BID #24-05
ATH Fields Sprinkler and Drainage
Addendum Two

Released 11/27/2024

ADDENDUM: Addendum Two addresses questions received, the pre-bid meeting agenda, and pre-bid meeting attendance.

ROCK VALLEY COLLEGE ATHLETIC FIELD IMPROVEMENTS ROCKFORD, ILLINOIS

C. Typical cross-section of infield skin:

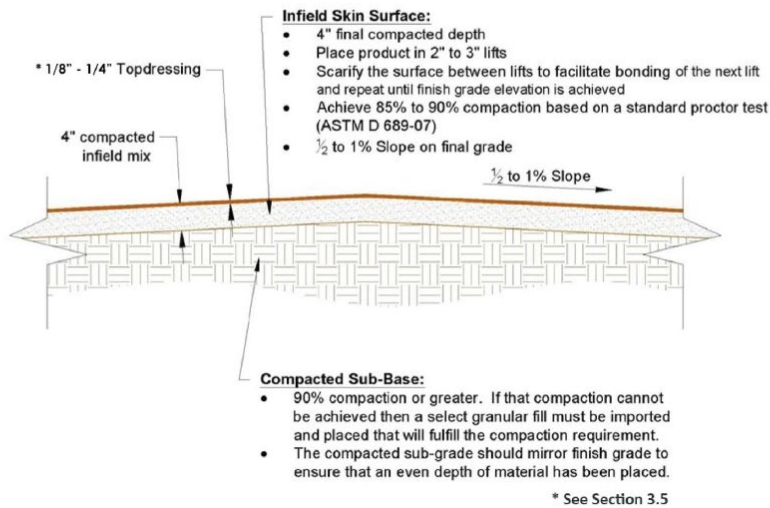
7. *Installing Turface Elite Champion Brown at a 4" depth will be a very loose and unstable surface. There will be little to no footing and very inconsistent ball bounce leading to a very unsafe surface. The material will break down overtime and after 1-2 years of play a low infield surface and lips around all the edges from the material migrating and moving. This material is meant to be a topdressing product that is placed at most 1/4" depth on top as a "Topdressing" – Cut sheet below.
- 8.

Infield Skin Surface:
DuraEdge Infield Mix

**ROCK VALLEY COLLEGE ATHLETIC
 FIELD IMPROVEMENTS
 ROCKFORD, ILLINOIS
 BASEBALL FIELD - GRADING
 AND EROSION CONTROL PLAN**

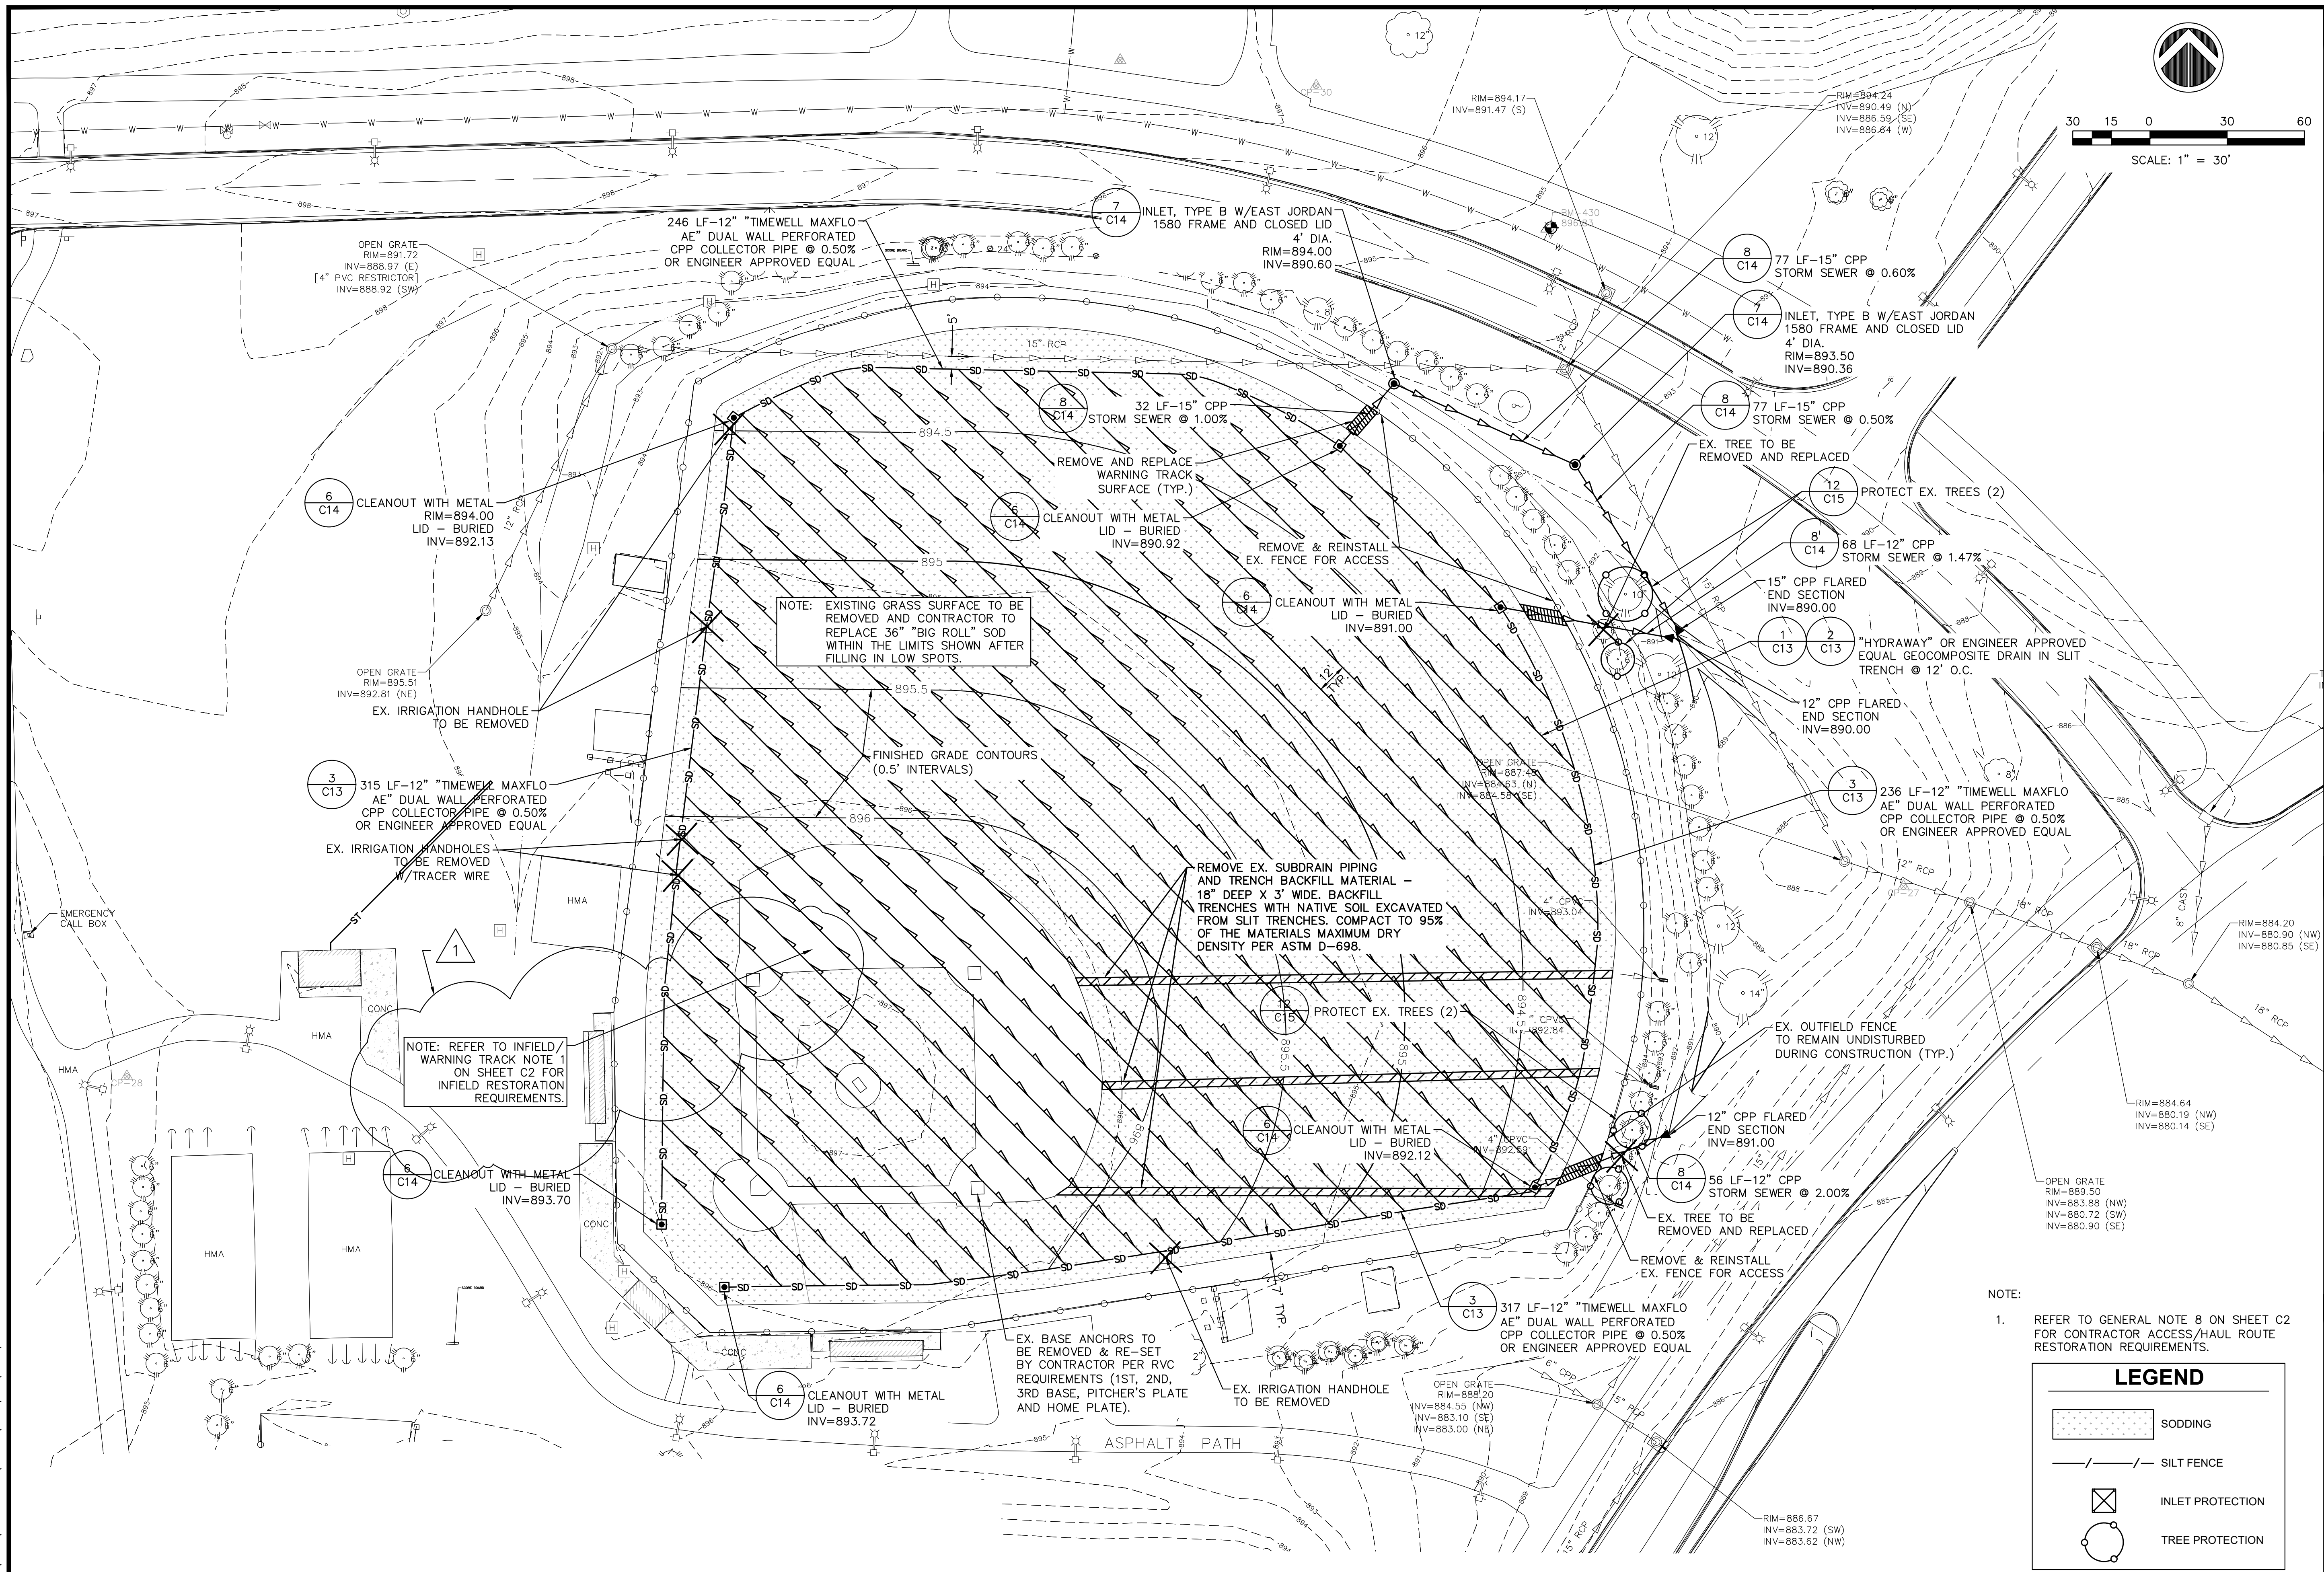
- a. Infield Surface restoration shall consist of a 4” thick placement and compaction of *DuraEdge Classic Infield Mix* and a 1/8” to ¼” thickness of *Turface Elite Championship Brown* top dressing, as shown on revised plan sheets C9 and C10.

- AFTER COMPLETION OF THE IRRIGATION AND SUBDRAINAGE SYSTEMS, THE INFIELD SHALL BE REMOVED AND REPLACED WITH A 4" THICKNESS OF DURA EDGE CLASSIC INFIELD MIX AND A 1/8" TO 1/4" TOPDRESSING OF TURFACE ELITE CHAMPIONSHIP BROWN, BOTH PRODUCTS ARE AVAILABLE FROM REINDERS.
- REPLACEMENT OF WARNING TRACK MATERIAL AND AREAS ALONG THE FIRST AND THIRD BASE LINES IN THE SOFTBALL FIELD SHALL BE WITH "TRAIL BLAZE WARNING TRACK STONE", WHICH CAN BE PURCHASED THROUGH FAULK'S BROS/WAUPACA SAND AND SOLUTIONS.

**ROCK VALLEY COLLEGE ATHLETIC
 FIELD IMPROVEMENTS
 ROCKFORD, ILLINOIS
 SOFTBALL FIELD - GRADING
 AND EROSION CONTROL PLAN**

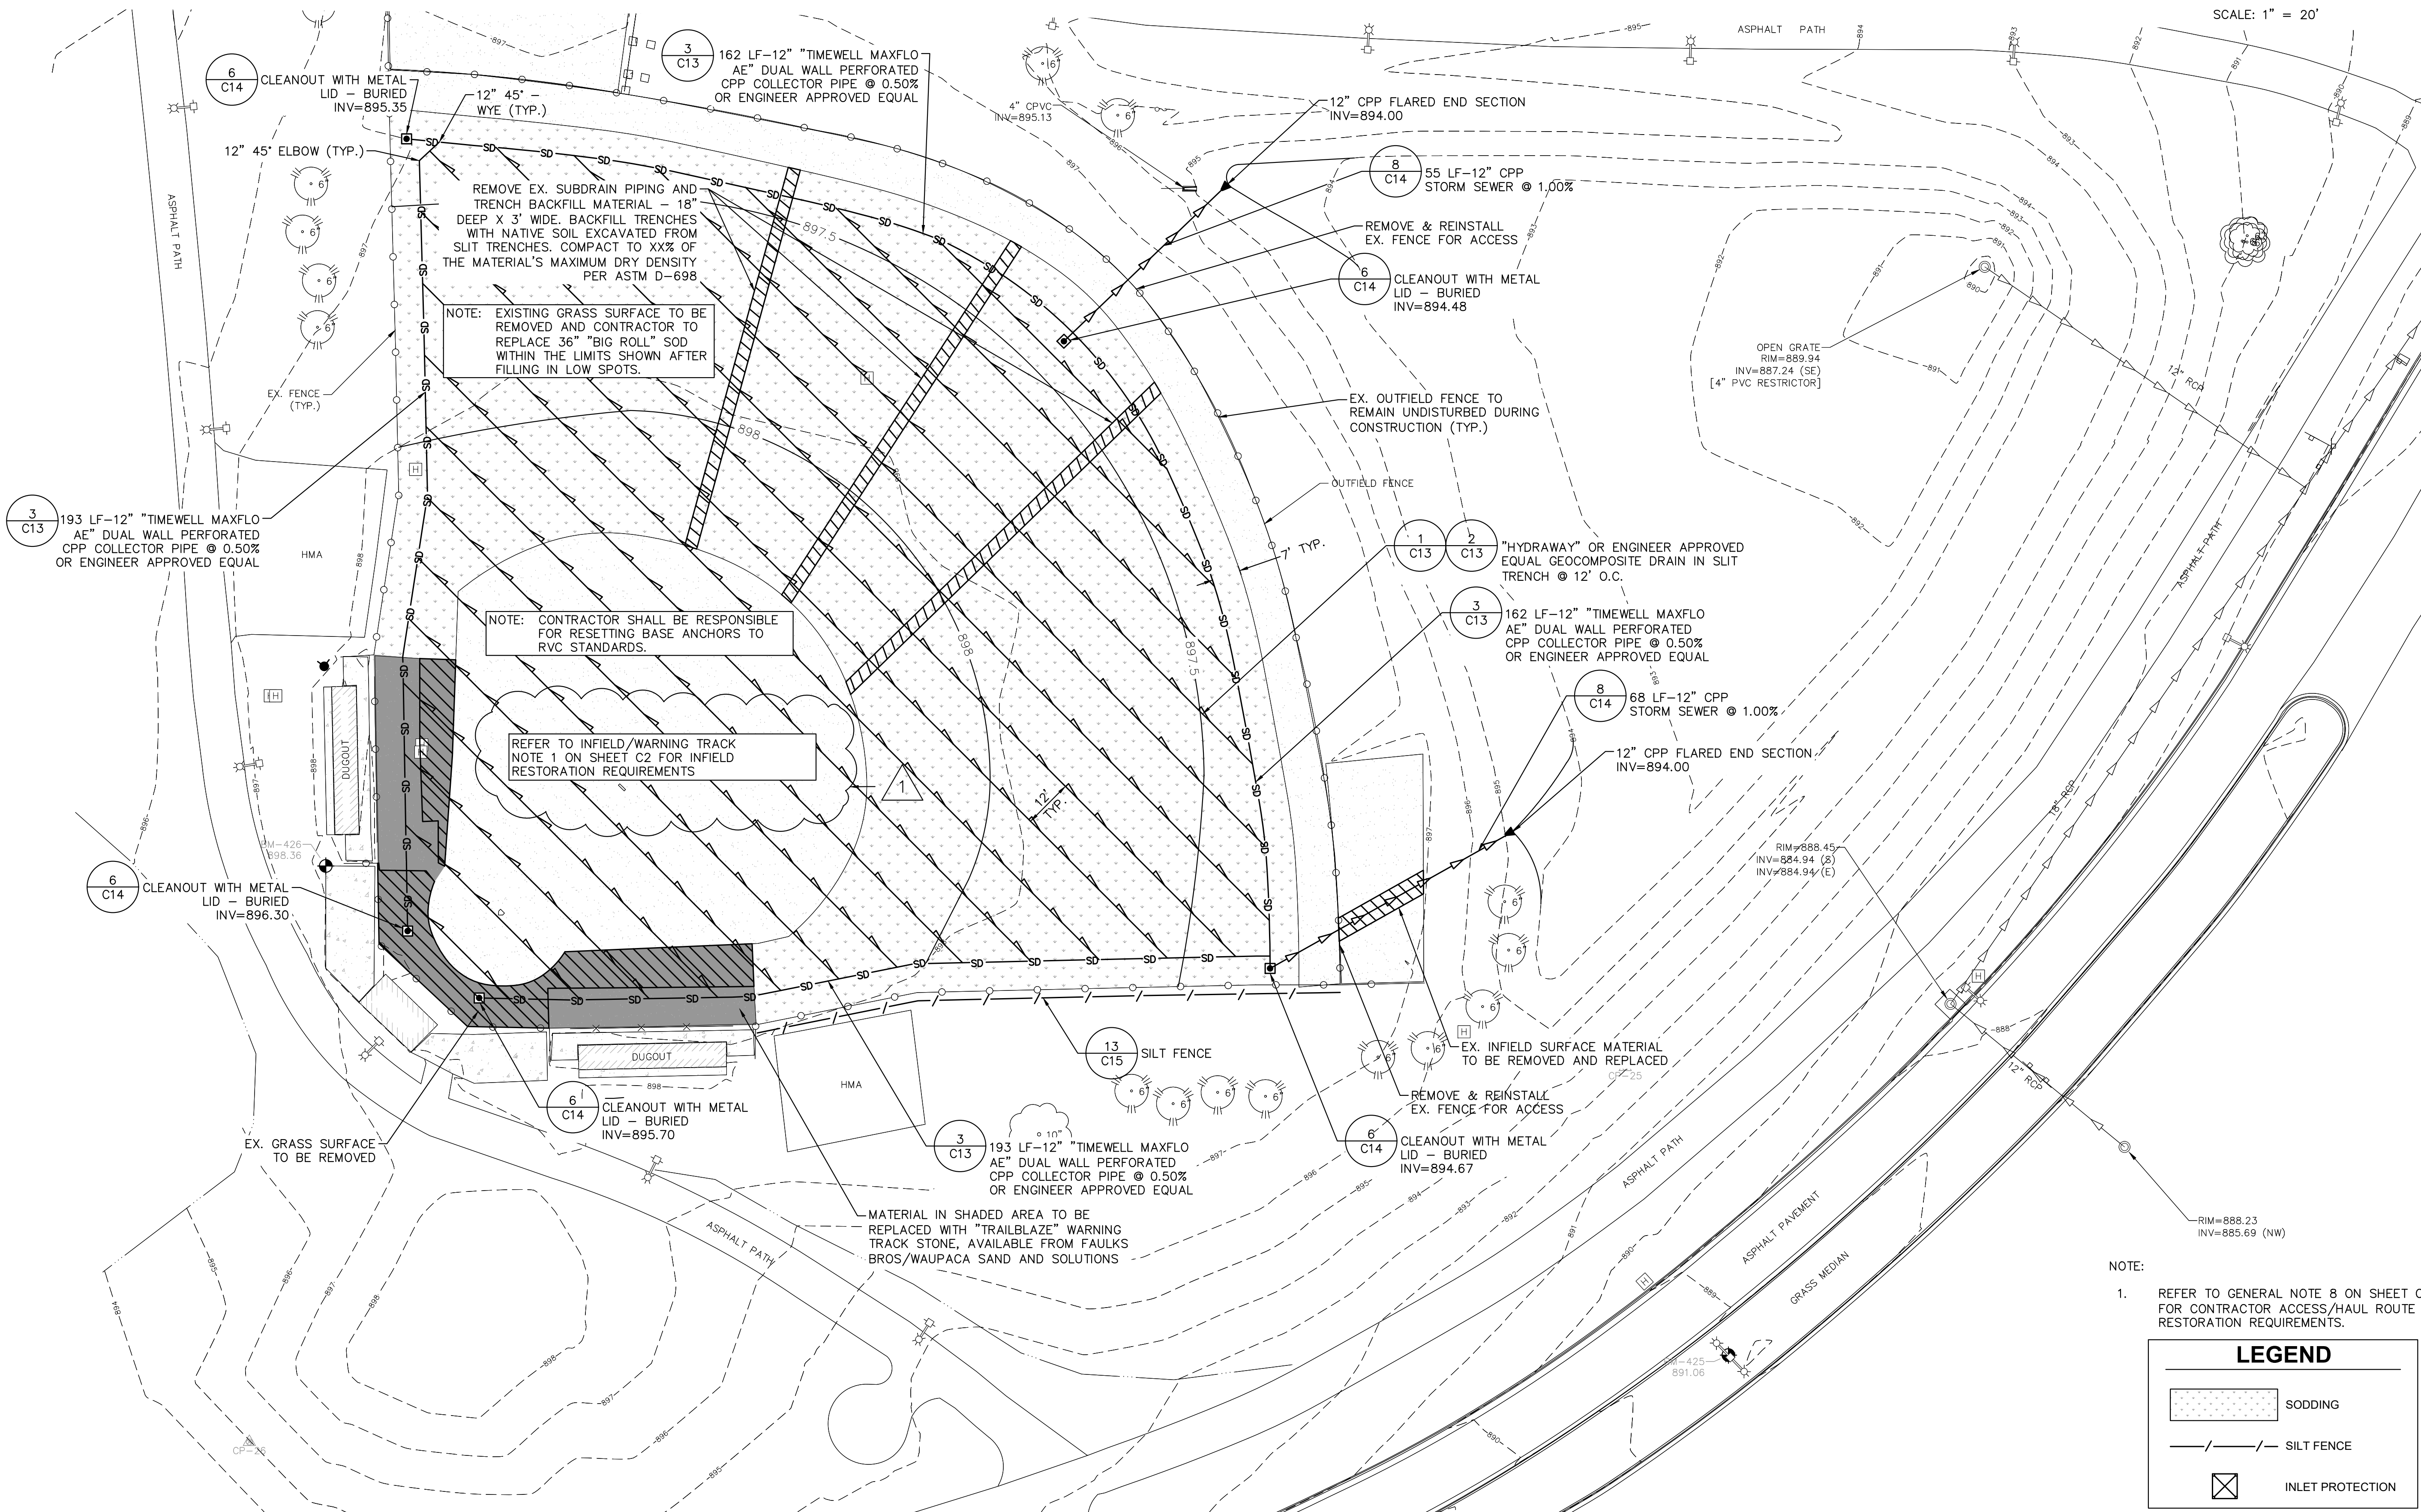
- c. Is there an anticipated start / end date for this project?
 - i.
- d. The infield surface for the softball field, (Plans – C10) is calling for 4” of Turface Championship Brown as the infield material. This product is not an infield base material and should be installed at 4” depth. Would you consider DuraEdge Classic Infield Mix for the 4” depth material on the softball field? Attached are the specifications. I also have the ProSlide Pro Brown Topdressing and Premium Mound Clay as well to be considered for this project.

6 C14 CLEAN OUT DETAIL
N.T.S.

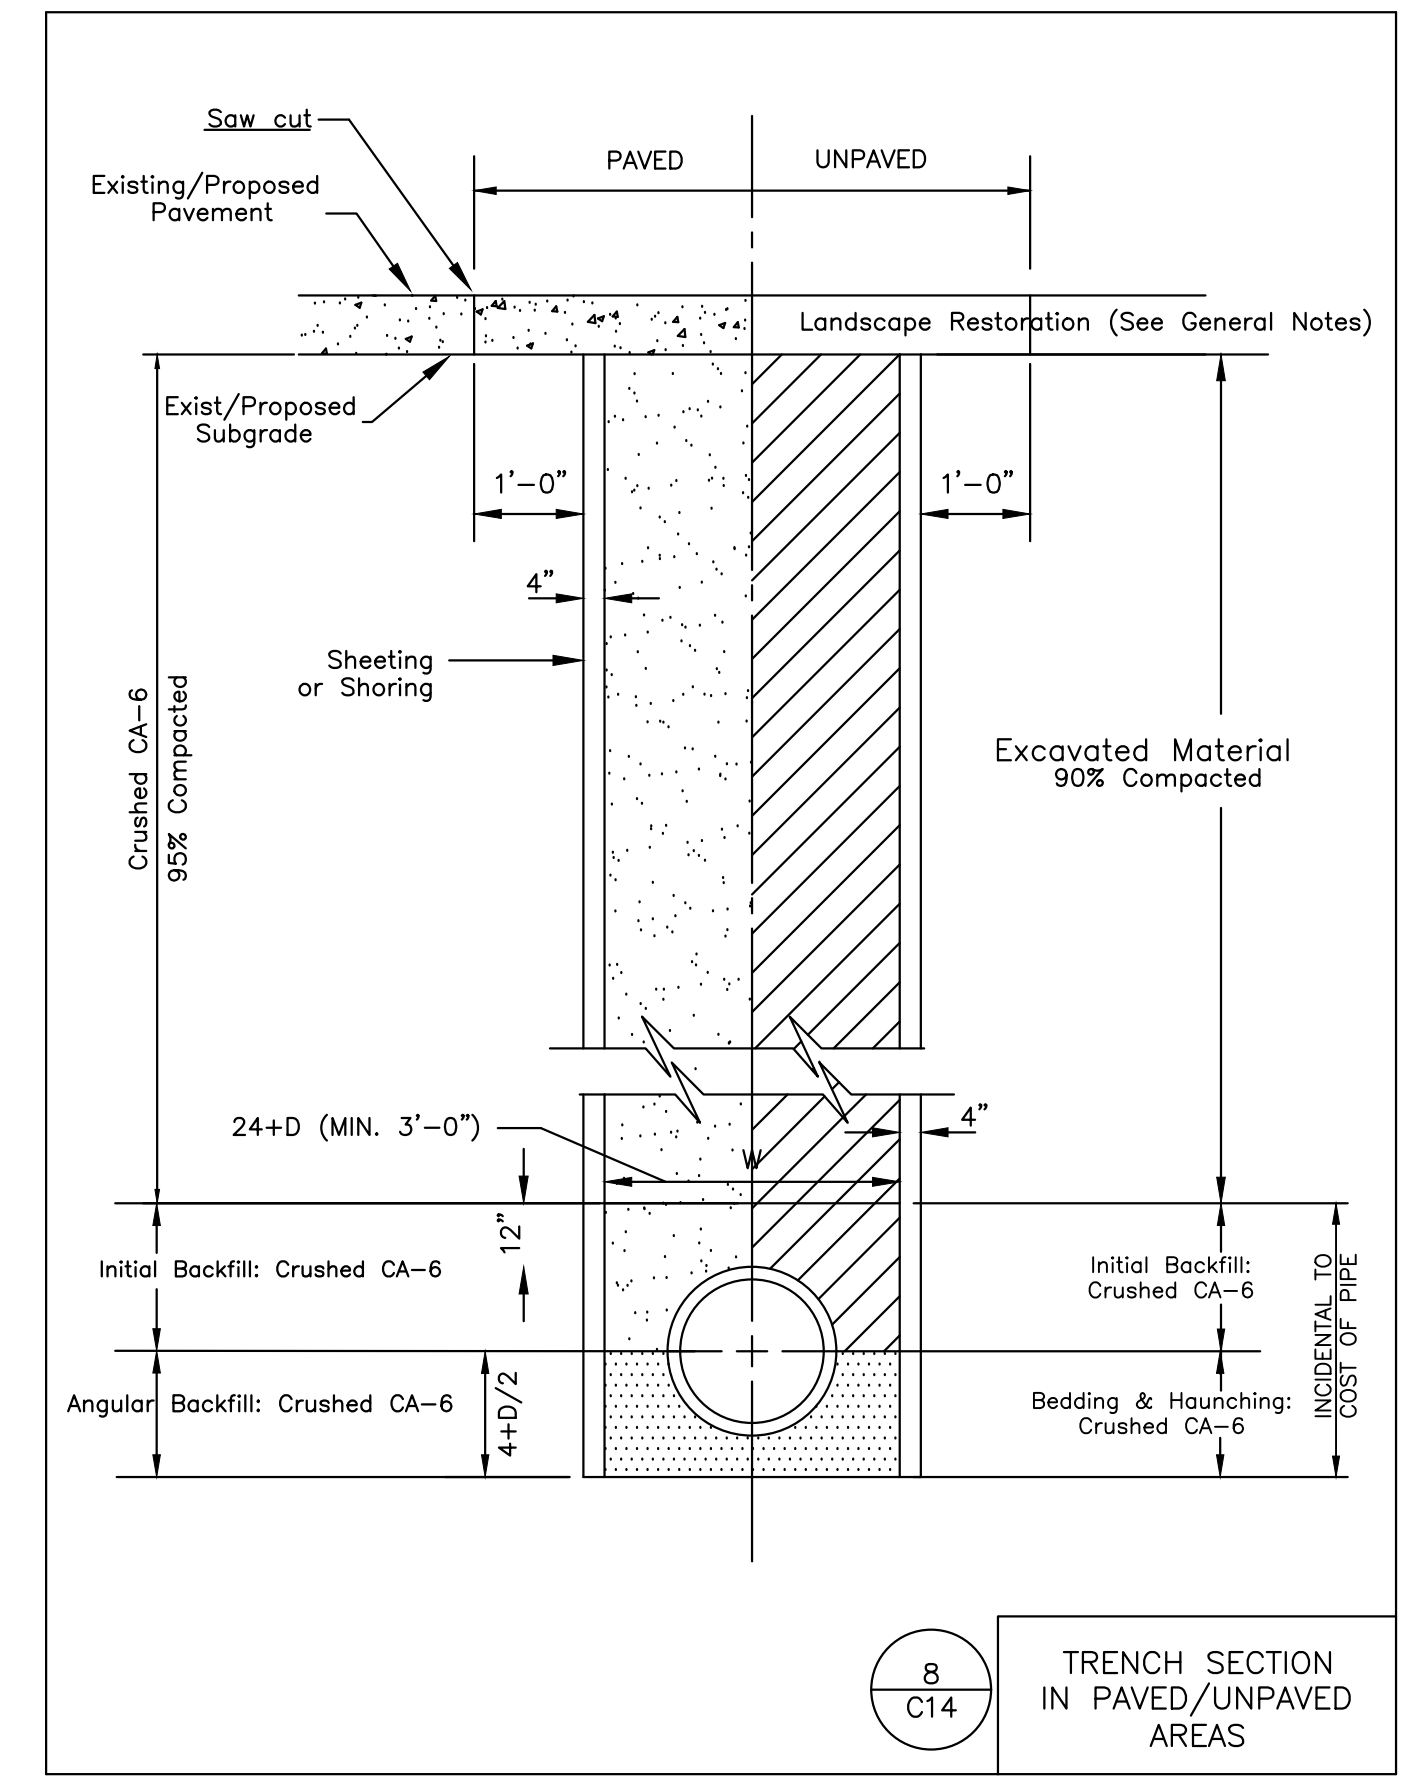
4. Cleanout Detail: Cleanout Detail No. 6 on Sheet C14 has been revised to require Timewell 12" x 6" Cleanouts with solid lids.
5. Is there an anticipated start / end date for this project?
 - o Desired start is as soon as possible. Anticipated end date is –follow up on this.
6. The infield surface for the softball field, (Plans – C10) is calling for 4" of Turface Championship Brown as the infield material. This product is not an infield base material and should be installed at 4" depth. Would you consider DuraEdge Classic Infield Mix for the 4" depth material on the softball field? Attached are the specifications. I also have the ProSlide Pro Brown Topdressing and Premium Mound Clay as well to be considered for this project.
